# 1995 - 1996 Corvette: Service Bulletin: Delayed Engagement (Replace Pump Cover Assembly)

**Subject:** Delayed Engagement (Replace Pump Cover Assembly)

**Bulletin Number:** 67-71-48

FIGURE 1. - HYDRA-MATIC 4L60-E TRANSMISSION IDENTIFICATION INFORMATION

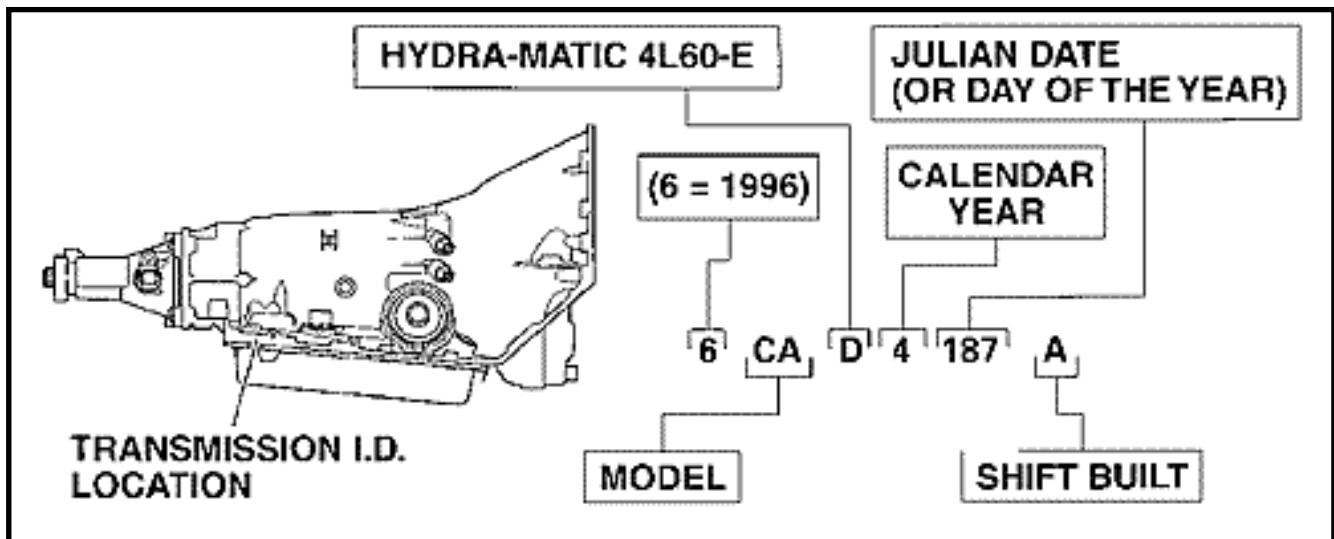
(FIGURES 1 AND 2) SOME OWNERS OF THE ABOVE MODELS, WITH A HYDRA-MATIC 4L60-E TRANSMISSION (BUILT BEFORE APRIL 29, 1996/JULIAN DATE 6120), MAY EXPERIENCE SOME DELAYED ENGAGEMENT WHEN VEHICLE IS NOT USED FOR MORE THAN 48 HOURS.

FIGURE 3. - TORQUE CONVERTER CLUTCH SIGNAL VALVE ASSEMBLY LOCATION

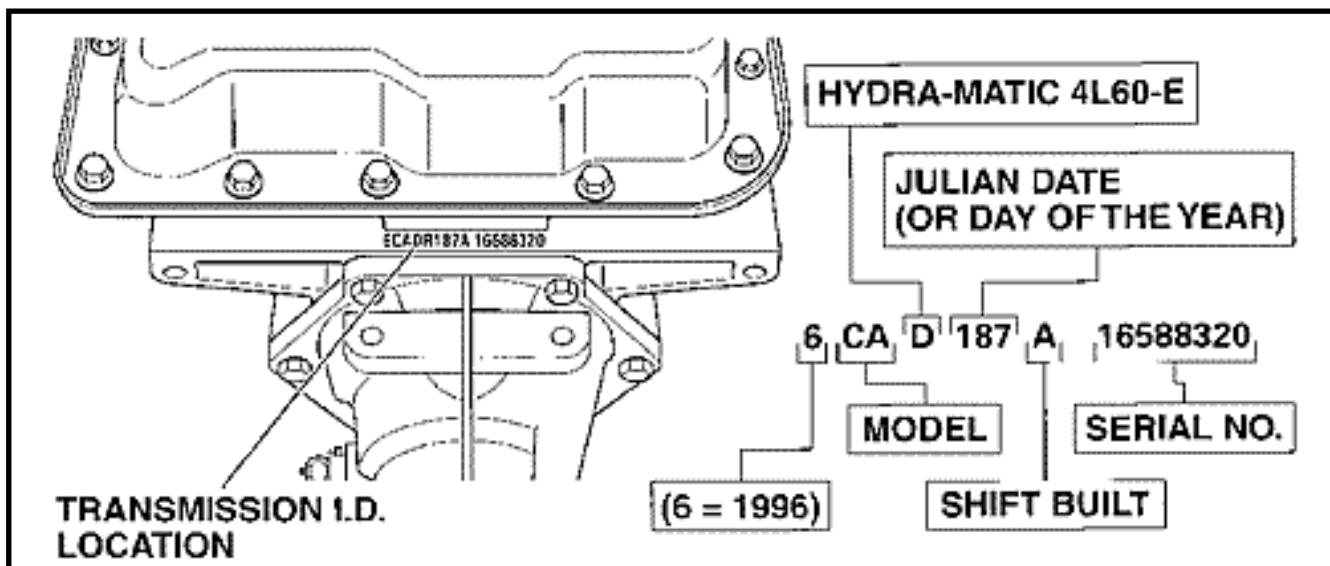
TORQUE CONVERTER FLUID LEVEL LOW DUE TO FLUID DRAIN DOWN.

(FIGURE 3) REPLACE PUMP COVER ASSEMBLY WITH THE NEW TCC SIGNAL VALVE ASSEMBLY.
